TO: Development Review Board
FROM: Scott Gustin
DATE: September 17, 2013
RE: 14-0061CA/MA; 87 King Street

Request: Rebuilding and renovation of the King Street Center on existing site.

Recommendation: Major Impact and Certificate of Appropriateness Approval as per, and subject to, the following findings and conditions:

Landscape Plan

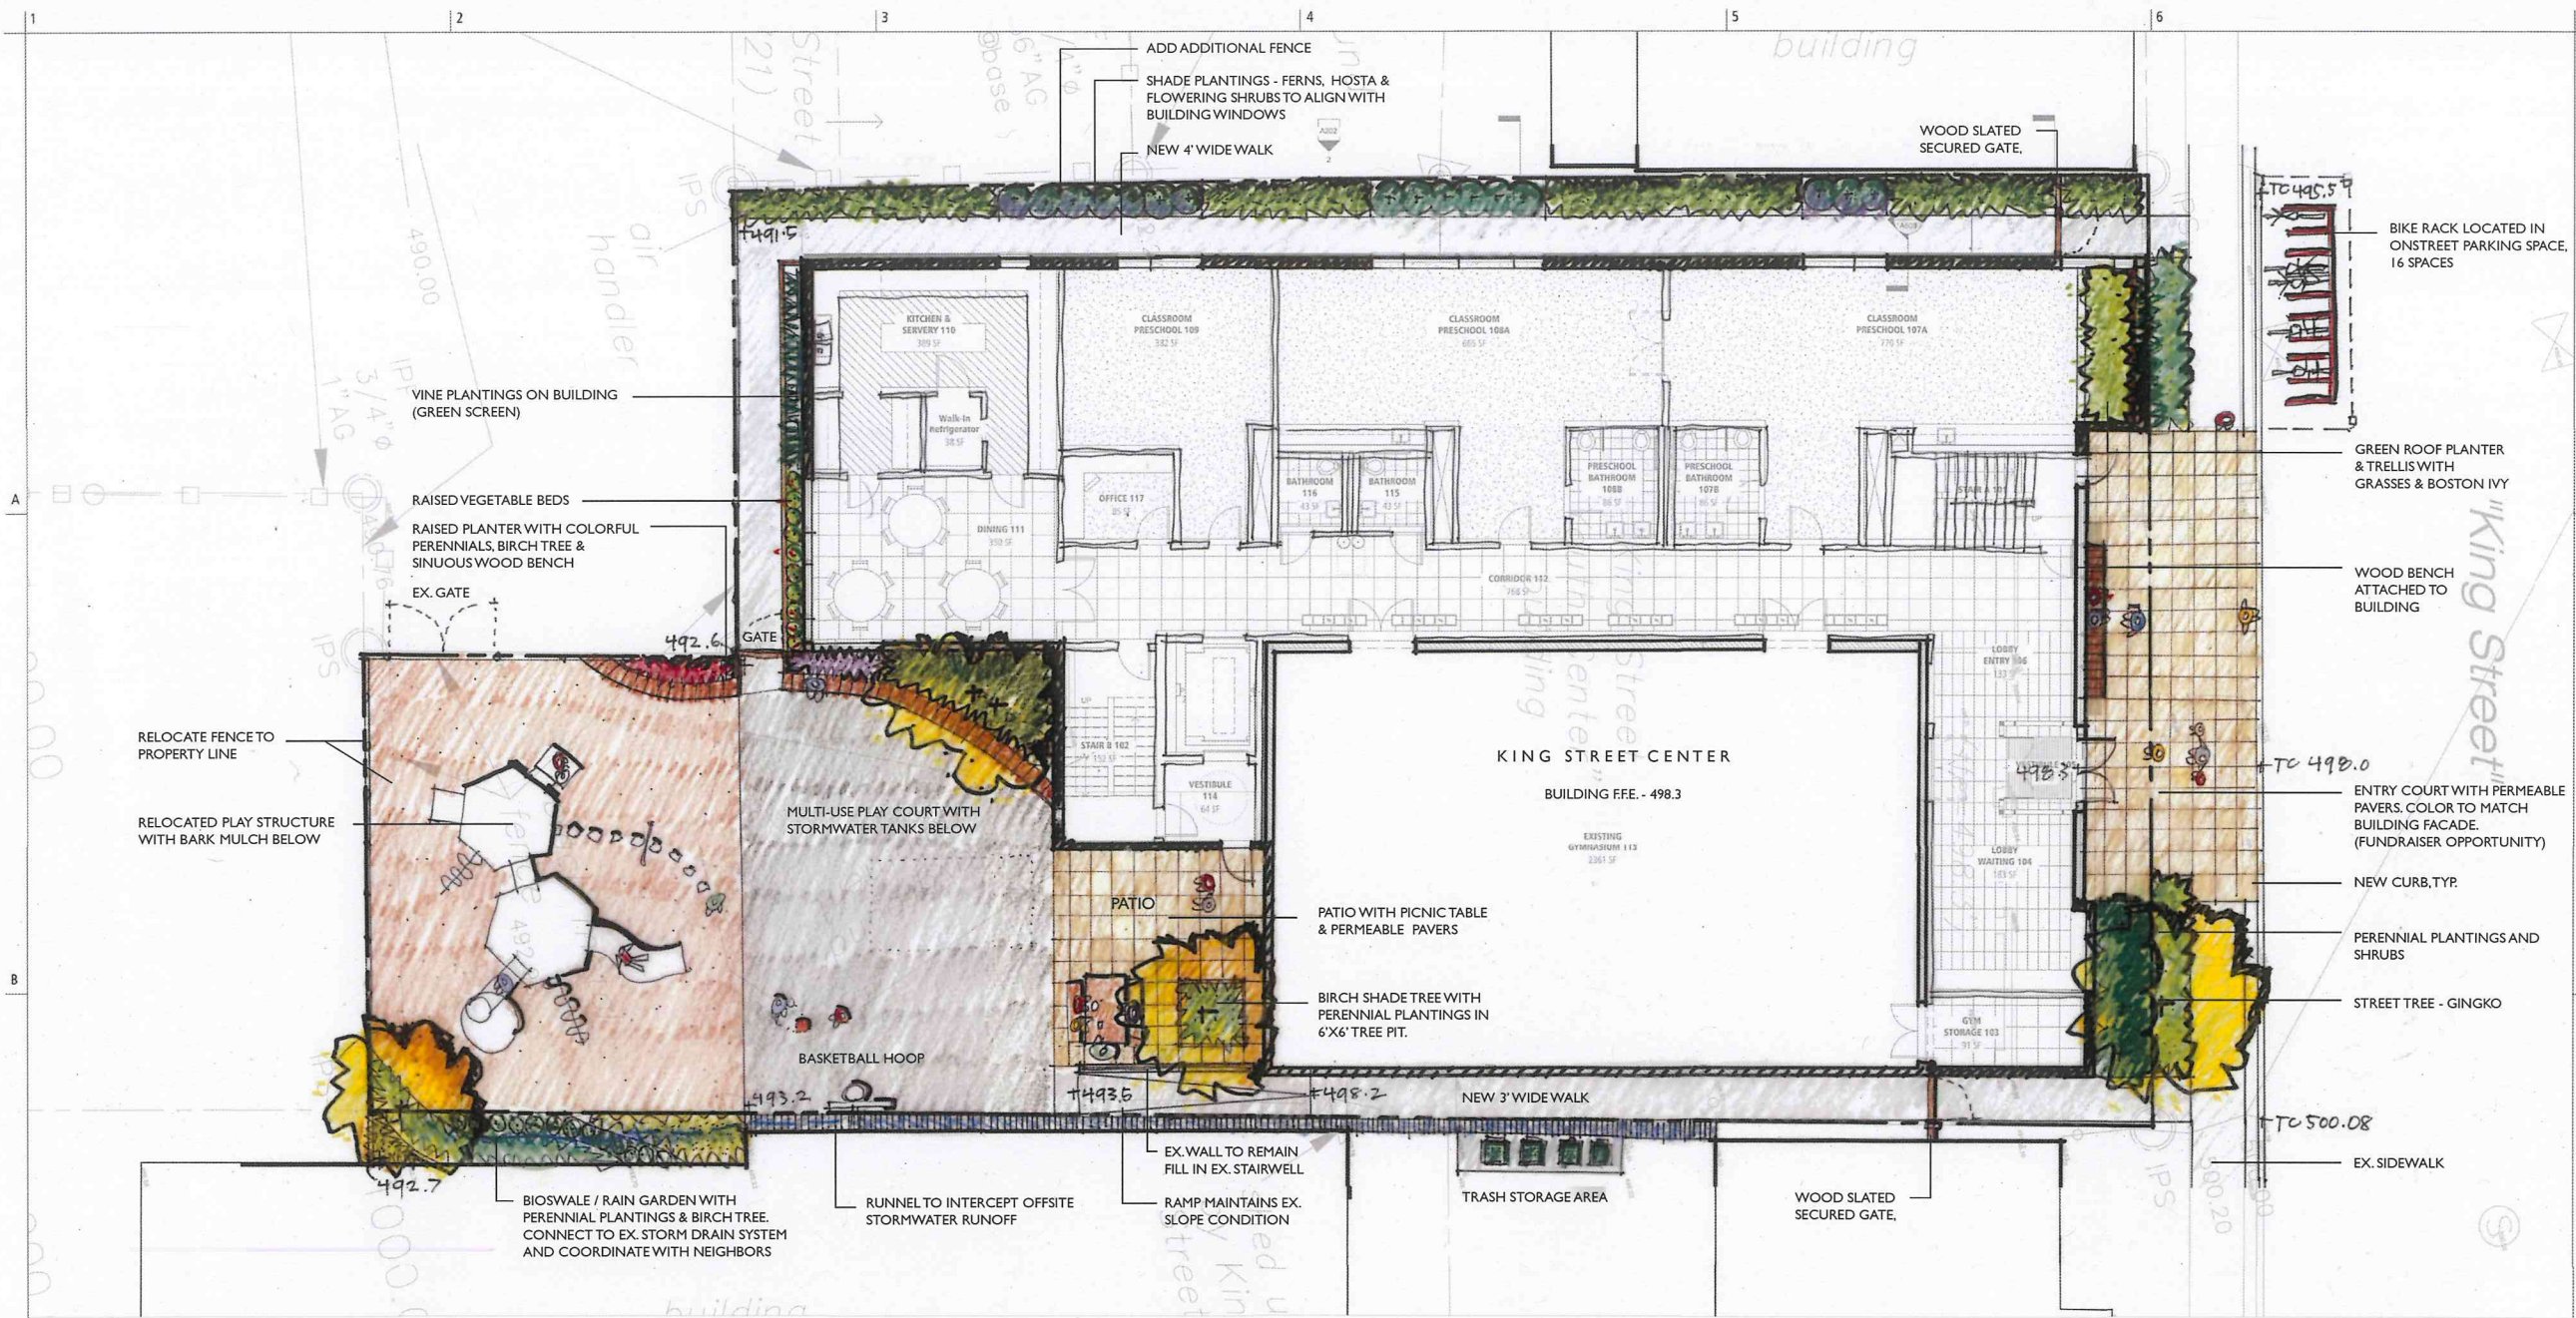
The project proposes significant perennial plantings along the front (north) elevation and parallel to the west walkway. Vines are proposed at the southerly building façade, with a raised bed landscaped area adjacent to the multi-use playcourt. A bioswale / raingarden is proposed for attenuation of stormwater at the southeasterly corner of the lot. New shade trees are proposed in four different locations on the very constrained site.

A single new street tree (a ginkgo) is proposed and is subject to approval by the City Arborist. **(Affirmative finding as conditioned)**

3. **Prior to release of the zoning permit**, the applicant shall receive written approval of the proposed street tree(s) from the City Arborist.
4. **Prior to release of the zoning permit**, the applicant shall provide information relative to noise levels generated by the proposed outdoor/rooftop mechanical equipment, subject to staff review and approval.

Lighting Plan

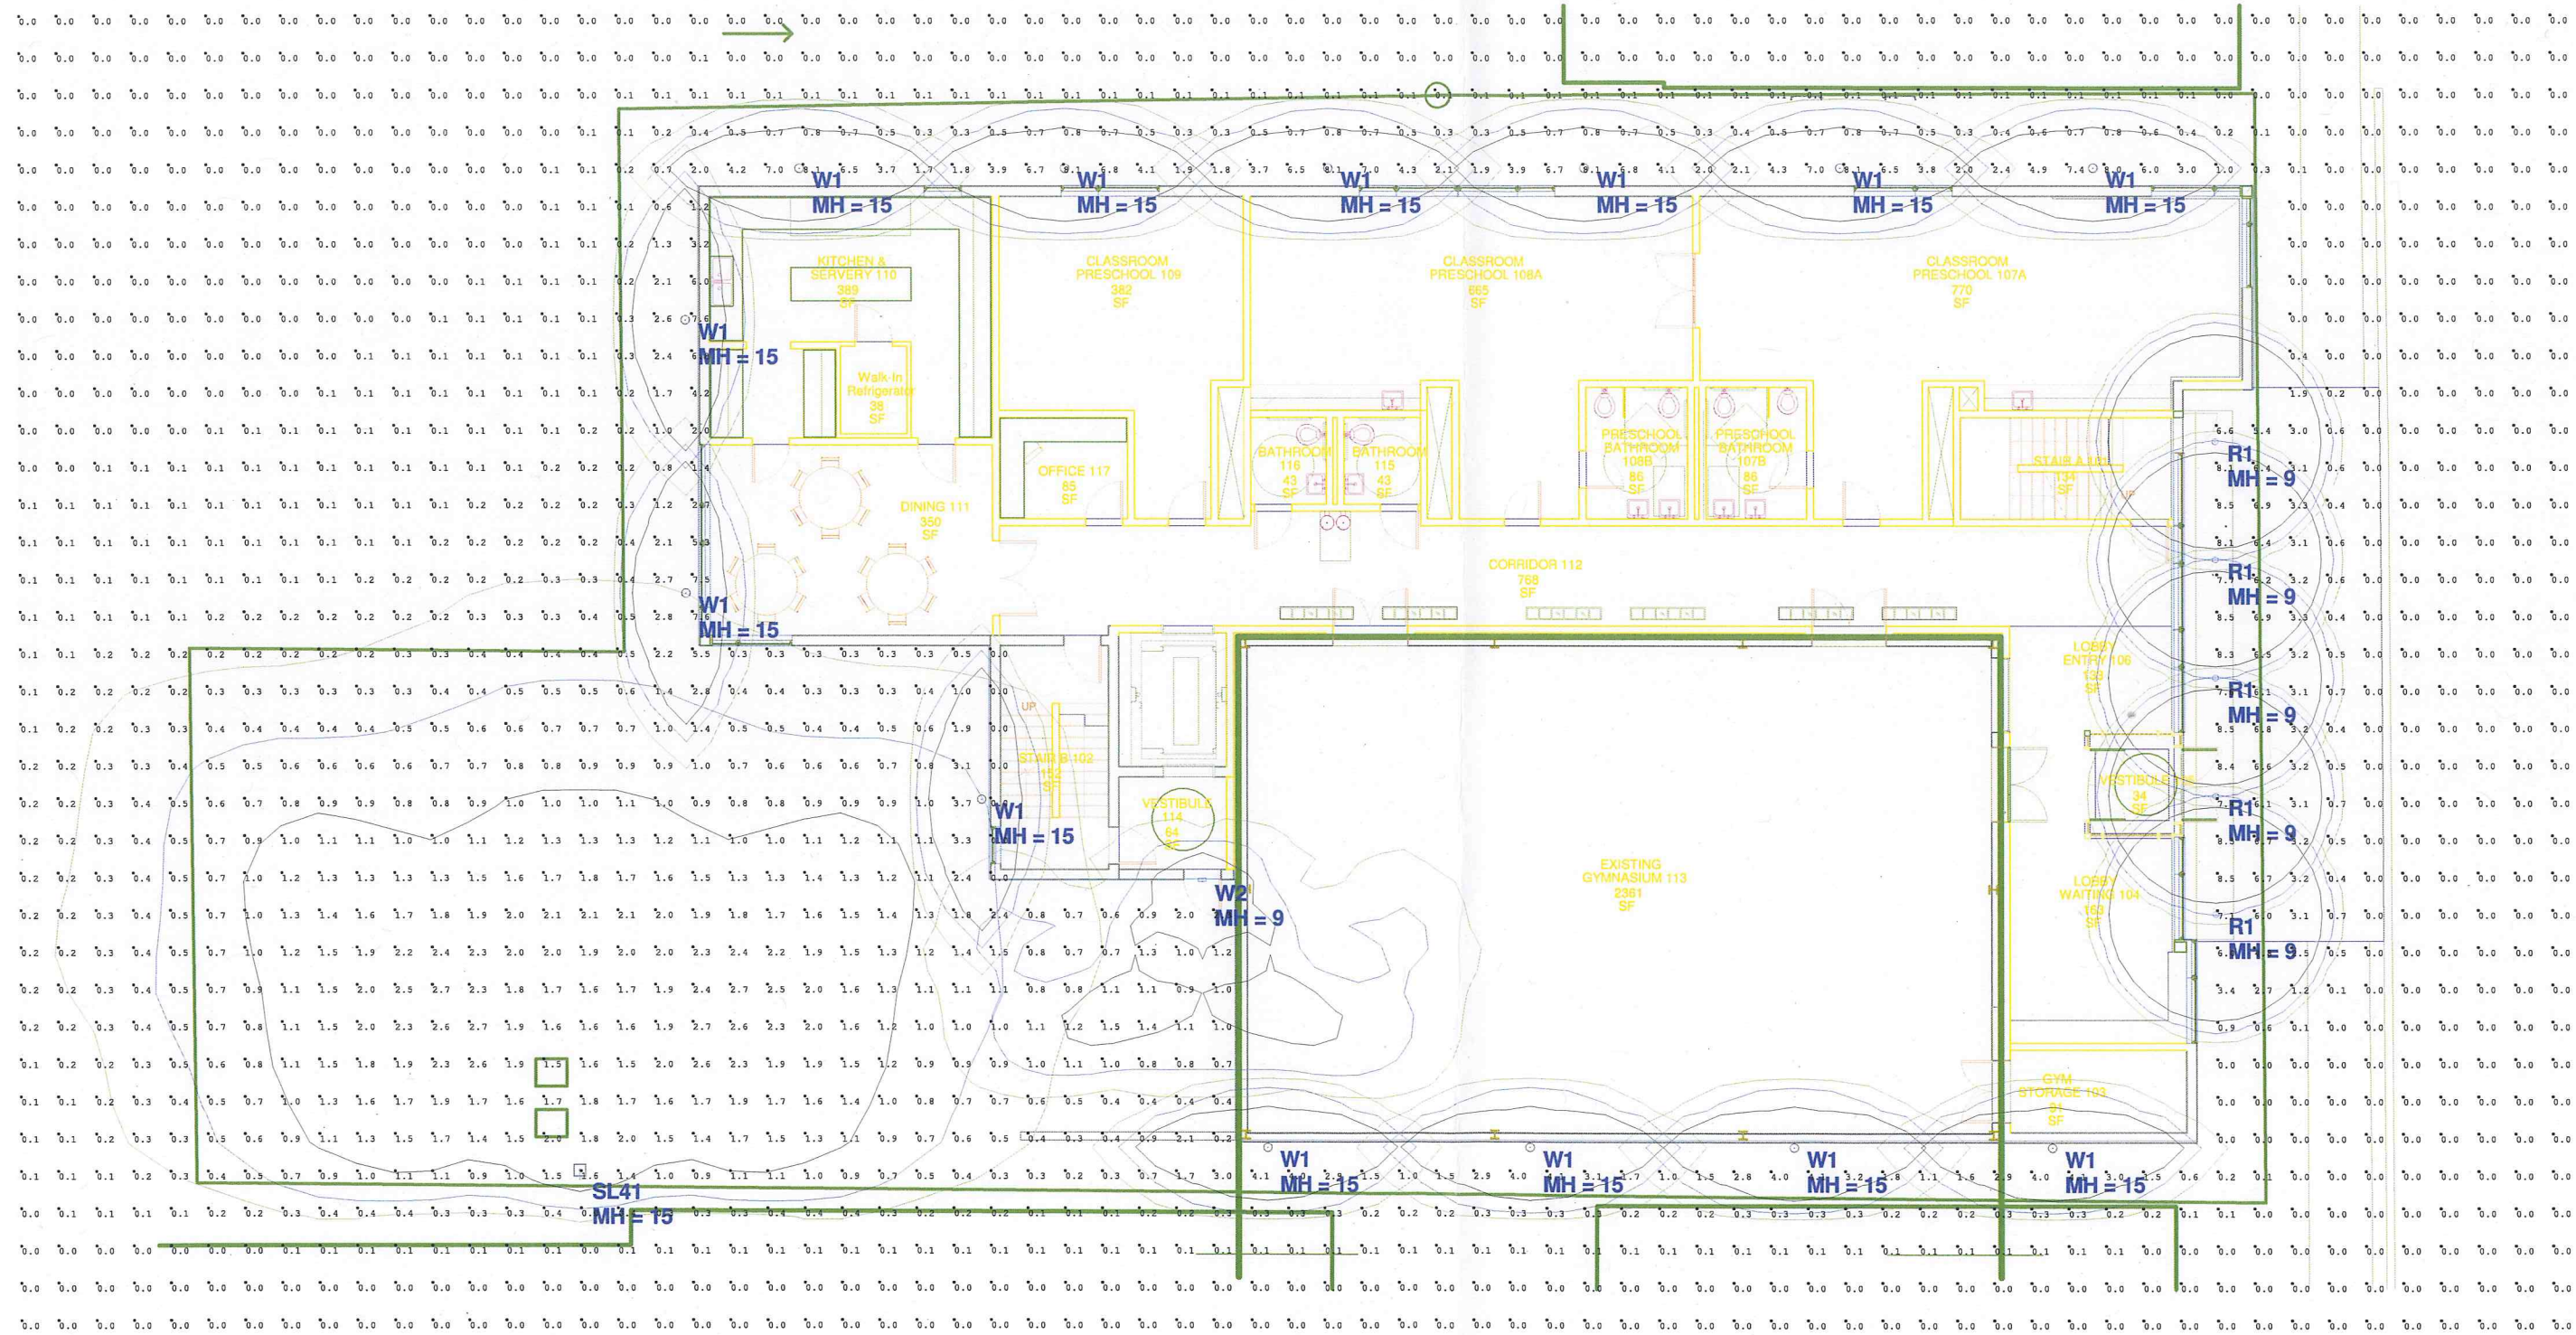
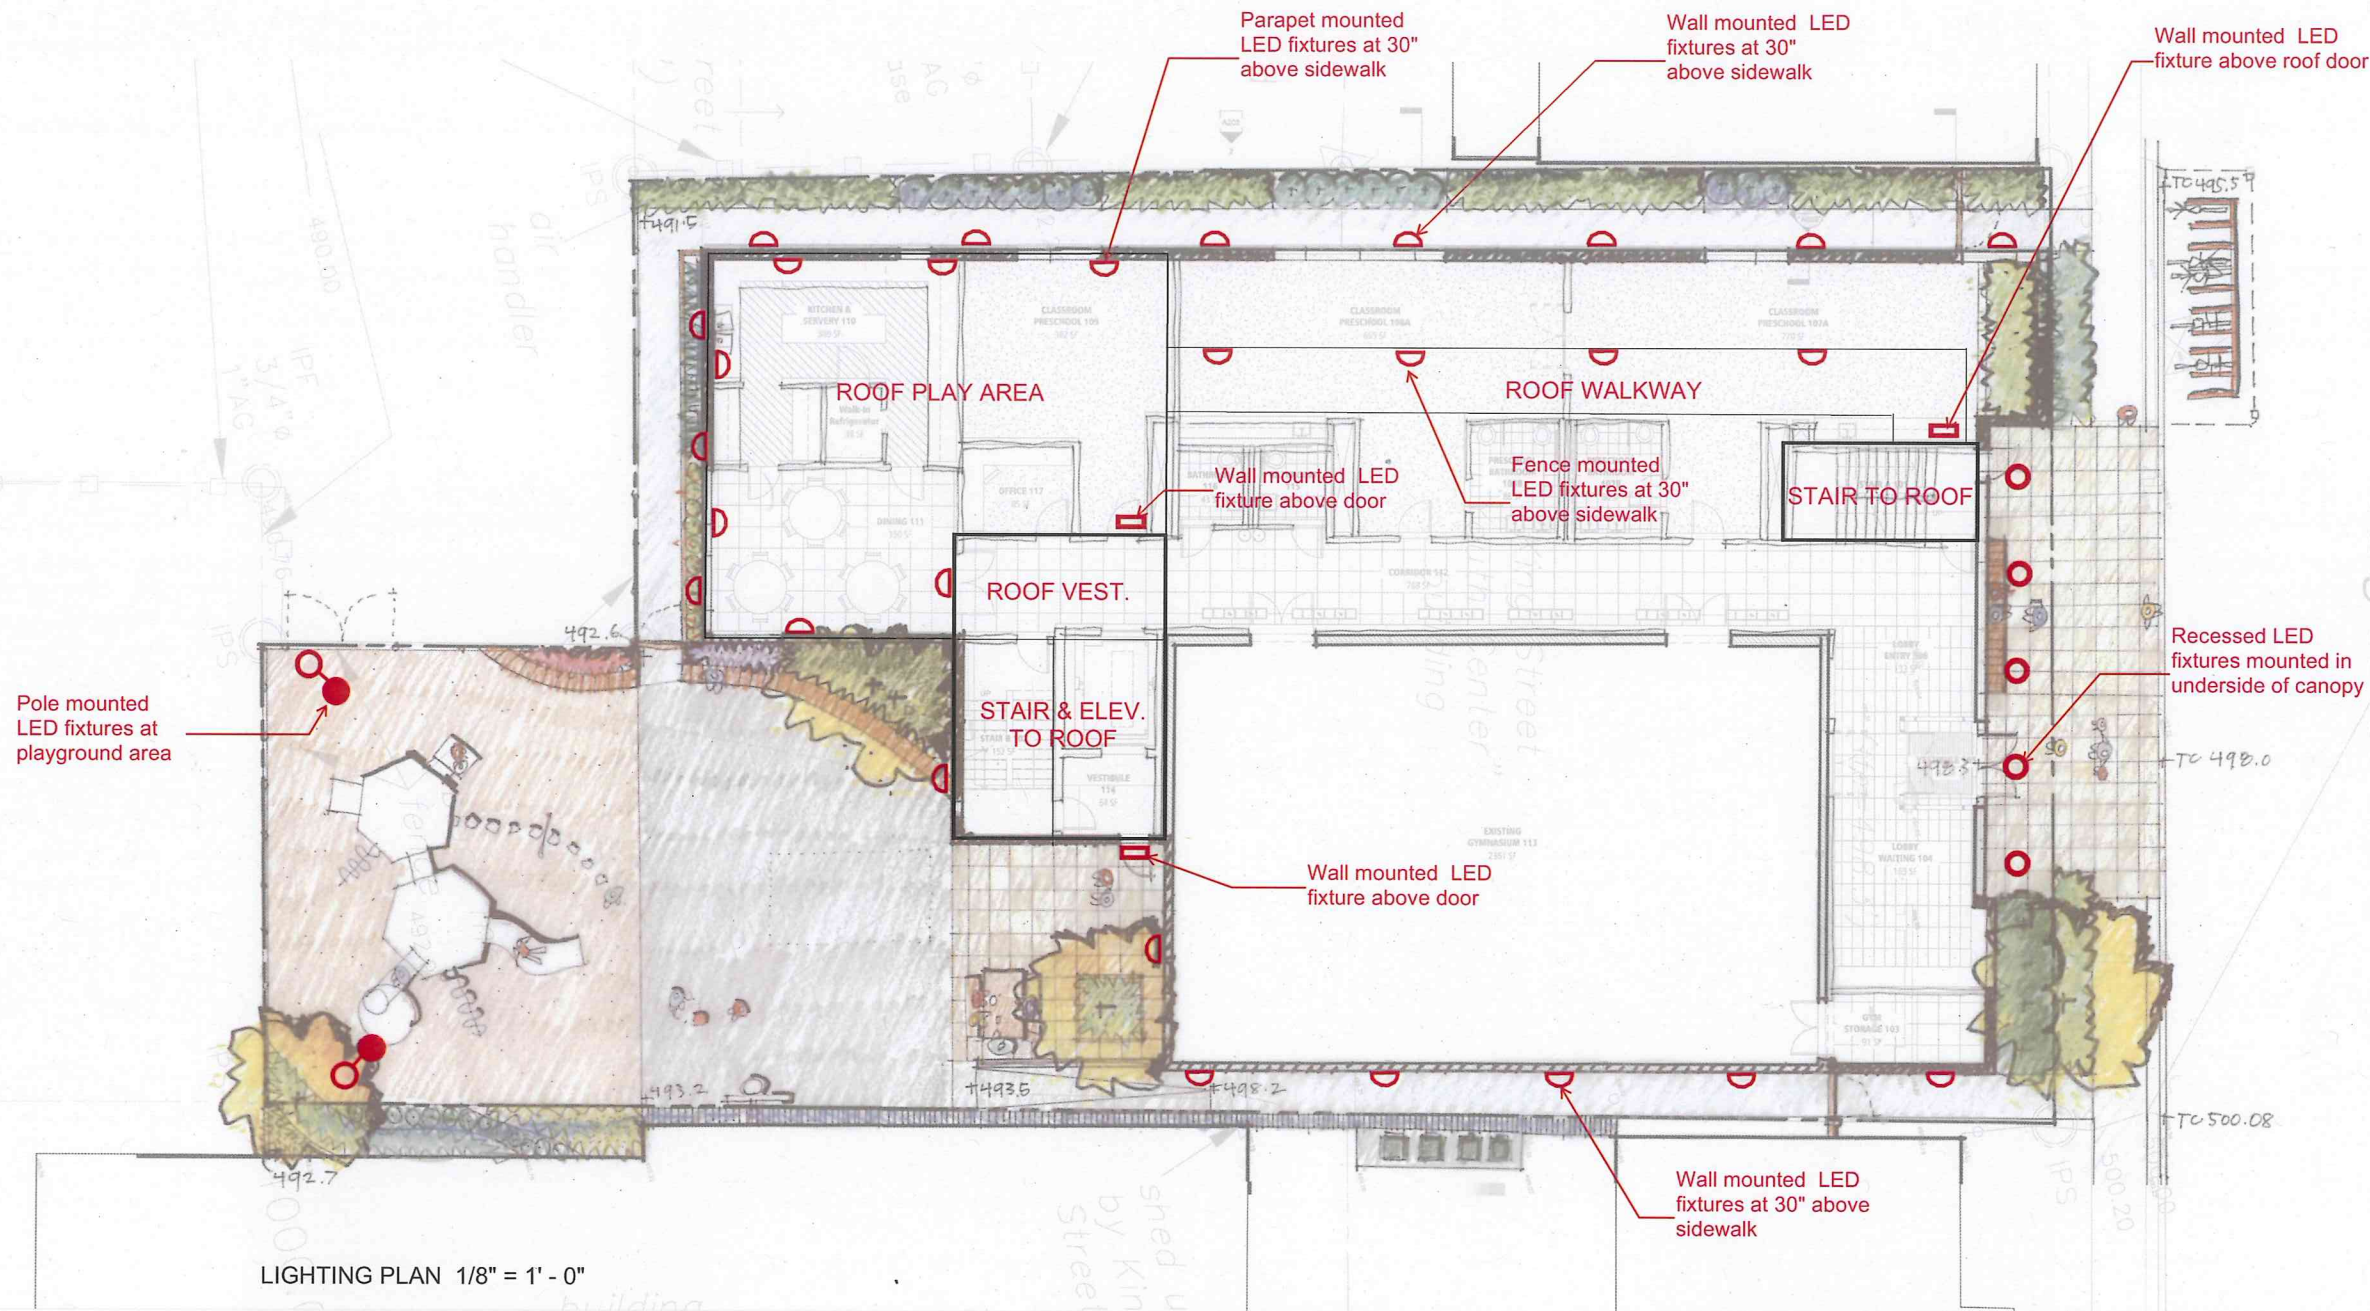
Outdoor lighting information has been provided, but additional information is needed. Three of the four proposed fixture types are noted on the Lighting Plan and are generally acceptable except for some bright spots noted on the photometric plan. All four of the proposed fixtures must be displayed on the Lighting Plan. The photometric plan shows site illumination levels but is in need of additional/corrected information. Illumination of the two walkways needs to be separately tabulated with minimum, maximum, and average illumination levels. The same is needed for the rear play area. The illumination of the front entry is plainly above the maximum allowable level of 5.0 footcandles and must be revised to lessen illumination levels. Lastly, the number and placement of lighting fixtures on the photometric plan does not match those on the Lighting Plan and must. The lighting plan is generally acceptable but adjustments are needed. **(Affirmative finding as conditioned)**

2. **Prior to release of the zoning permit**, a revised outdoor lighting plan shall be submitted, subject to staff review and approval. The revised lighting plan shall depict all proposed fixture types. The photometric plan shall tabulate the two walkways separately with minimum, maximum, and average illumination levels tabulated. The same shall be done for the back yard play area. Illumination of the front entry shall be reduced to no more than 5.0 footcandles. The number and placement of lighting fixtures in the photometric plan shall match the number and placement of lighting fixtures in the lighting plan.
